DEVELOPMENT APPLICATION ASSESSMENT REPORT

Application Number:	DA2023/1869
----------------------------	-------------

Responsible Officer:	Thomas Prosser
Land to be developed (Address):	Lot 5B DP 158658, 58 Beaconsfield Street NEWPORT NSW 2106 Lot 6 DP 1096088, 56 Beaconsfield Street NEWPORT NSW 2106 Lot 7B DP 162021, 54 Beaconsfield Street NEWPORT NSW 2106
Proposed Development:	Demolition works and construction of a Residential Flat Building including the consolidation of 3 lots into 1 lot
Zoning:	R3 Medium Density Residential
Development Permissible:	Yes
Existing Use Rights:	No
Consent Authority:	Northern Beaches Council
Delegation Level:	NBLPP
Land and Environment Court Action:	No
Applicant:	Jak Newport Pty Ltd

This proposal seeks consent for demolition of existing dwellings, consolidation of three lots into one lot, and the construction of a new 13-unit residential flat building.

Figure 1: Height blanket diagram (provided by applicant)

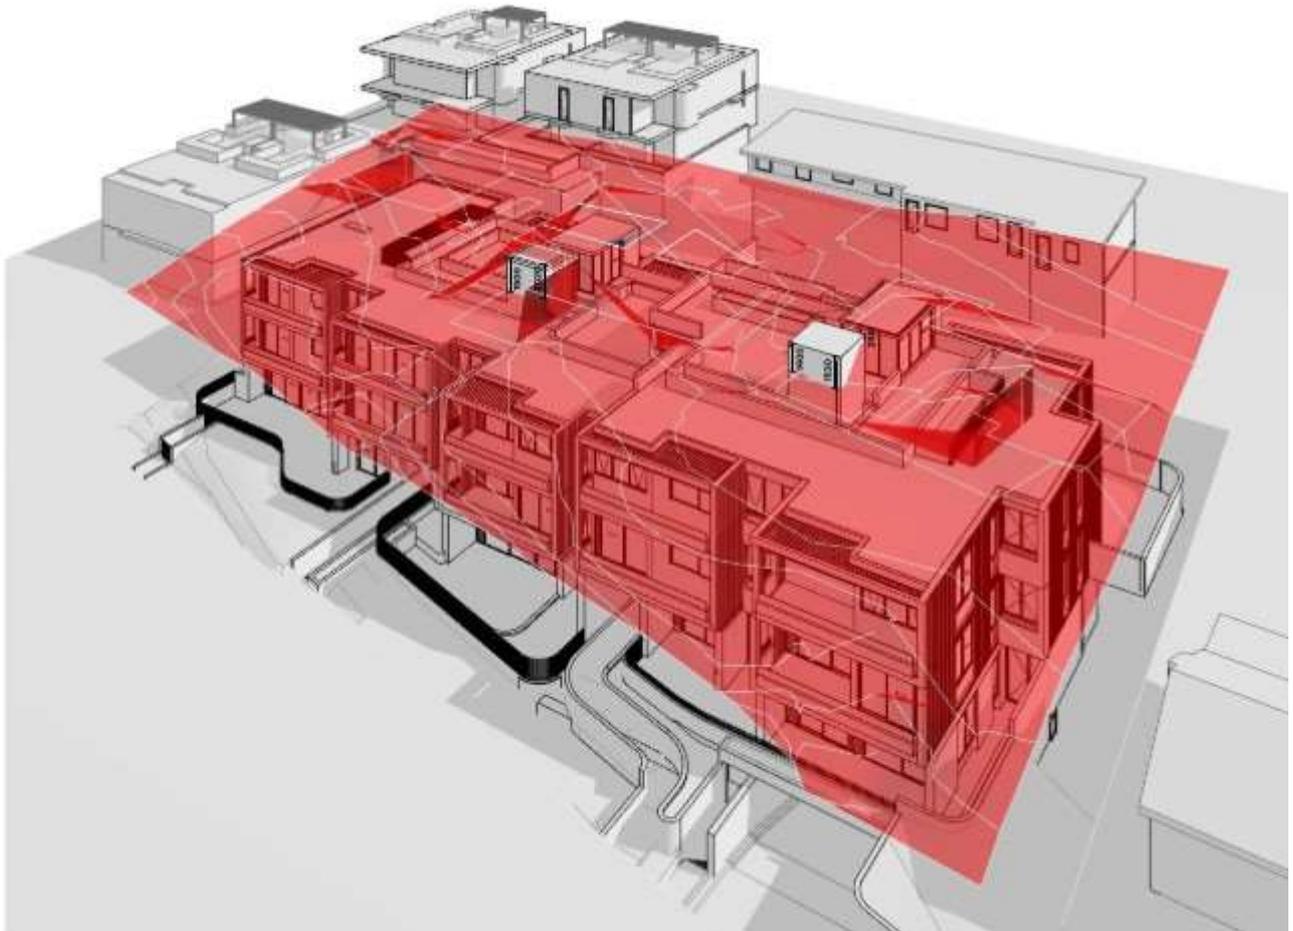
The Clause 4.6 request in relation to the non-compliance with the building height standard arises from a minor portion of the building (lift overruns), being above the 8.5m standard and up to 10.0m (17.6% variation). The lift overruns provide access to the Communal Open Space (required by ADG), will have no unreasonable amenity or visual impact, and is supported by information from a lift manufacturer to show that the height of the structures size have been minimised. The breach is addressed within the Clause 4.6 assessment within the body of this report and is supported on merit.

The majority of the building footprint and envelope complies with the development standard for Building Height. The non-compliance with the numerical standard for Building Height relates to a section of the lift overrun. These lift overruns, provide access (including disability access) to communal open space (which is required by the Apartment Design Guide).

Council is satisfied that the applicant has demonstrated that there are sufficient environmental planning grounds to justify the contravention of Clause 4.3 for the following reasons:

- The proposed lift structures will provide compliant access to the communal open space (as required by the Apartment Design Guide).
- It is agreed that there is an absence of any material impacts.
